RE: **Lot 3 Block 2 Volcano Cliffs Unit 22 SAD 228**
8016 Canoncito NW Revised
Grading and Drainage Plan
Engineers Stamp Date 12/24/19 (D10D003C3)
Pad Certification Date 12/3/19

DRAINAGE AND TRANSPORTATION INFORMATION SHEET (REV 6/2018)

ENGINEER'S SEAL	LOT3 UN2 BLK22 VOLCANO CLIFFS SANCHEZ RESIDENCE	DRAWN BY DEM
	GRADING AND DRAINAGE PLAN	DATE 10-27-18
DAVID SOULE P.E. #14522	 1608 CENTRAL AVENUE SE SUITE 201 ALBUQUERQUE, NM 87106 (505) 972-0899	LOT 3 UN 2 BLK22 VOLCANO CLIFFS.DWG
		SHEET # C1
		JOB #

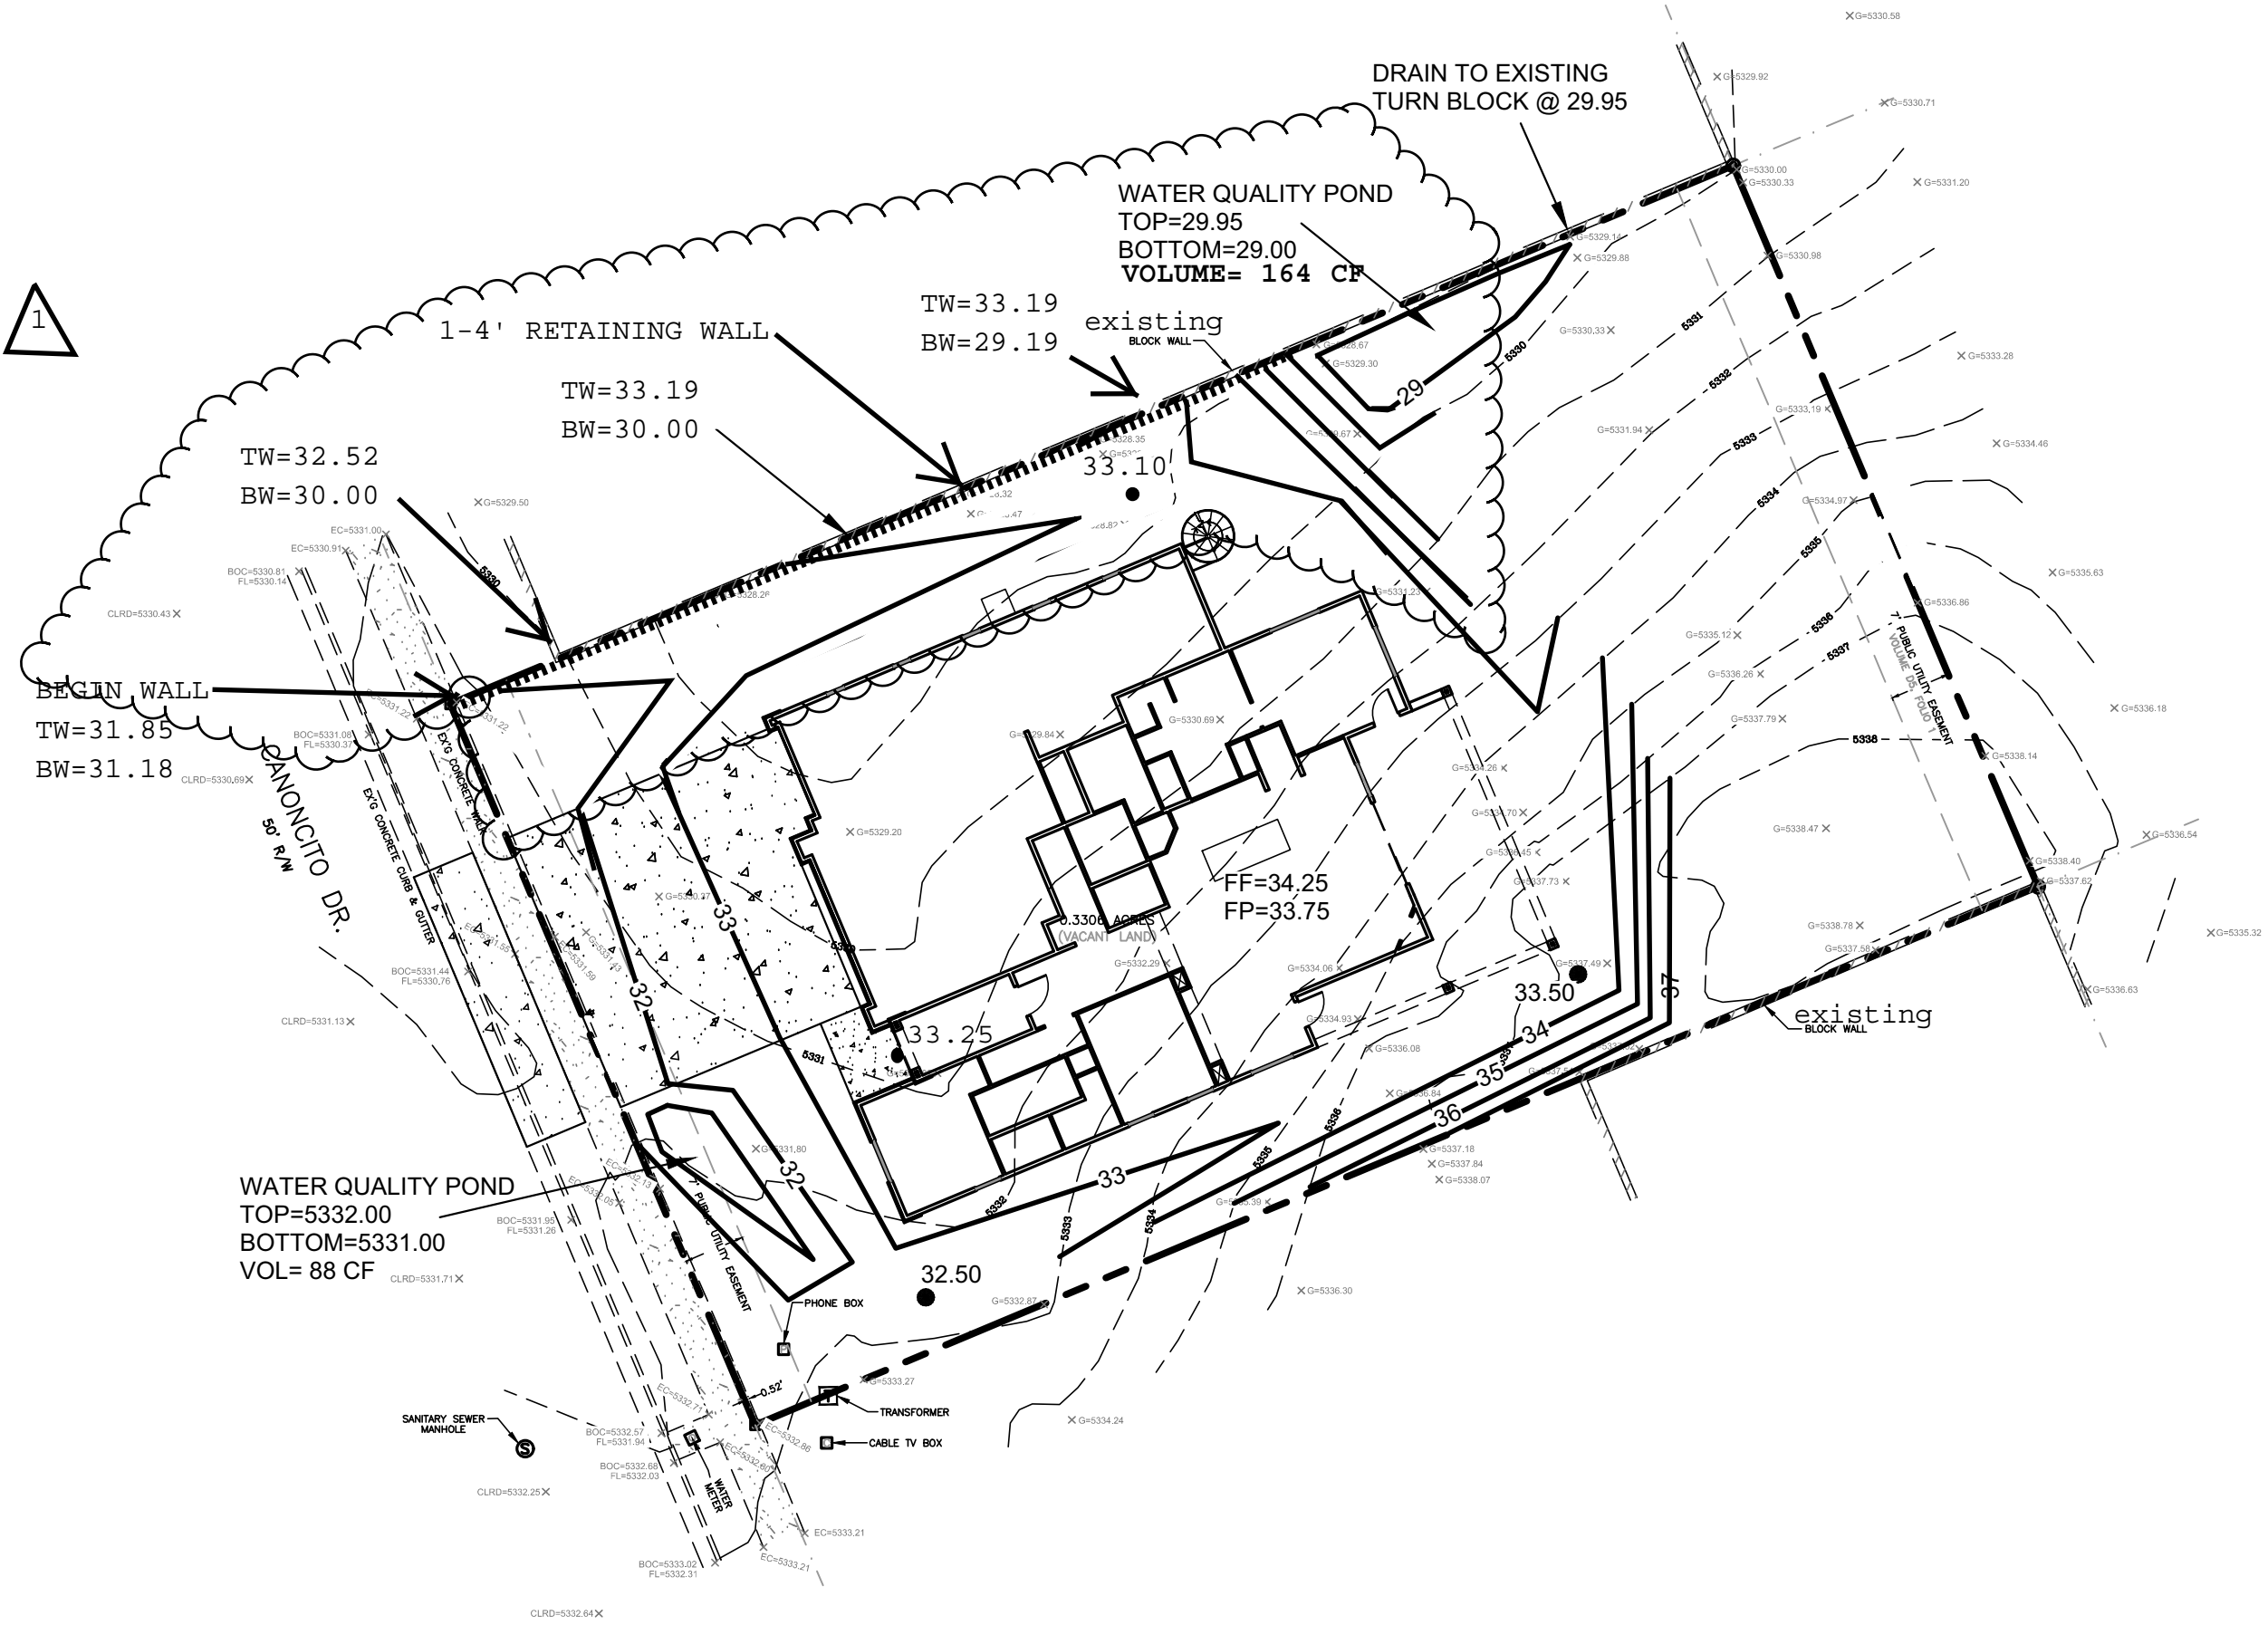
Based upon the information provided in your submittal received 12/24/19, this revised plan dated 12/24/19 is approved for Building Permit.

Reiterate to the Owner/Contractor that a separate permit for a garden/retaining wall must be obtained, with the approved G&D plan dated 12/24/19 and Pad Certification Date 12/3/19.

Prior to Certificate of Occupancy release, Engineer Certification per the DPM checklist of this plan will be required.
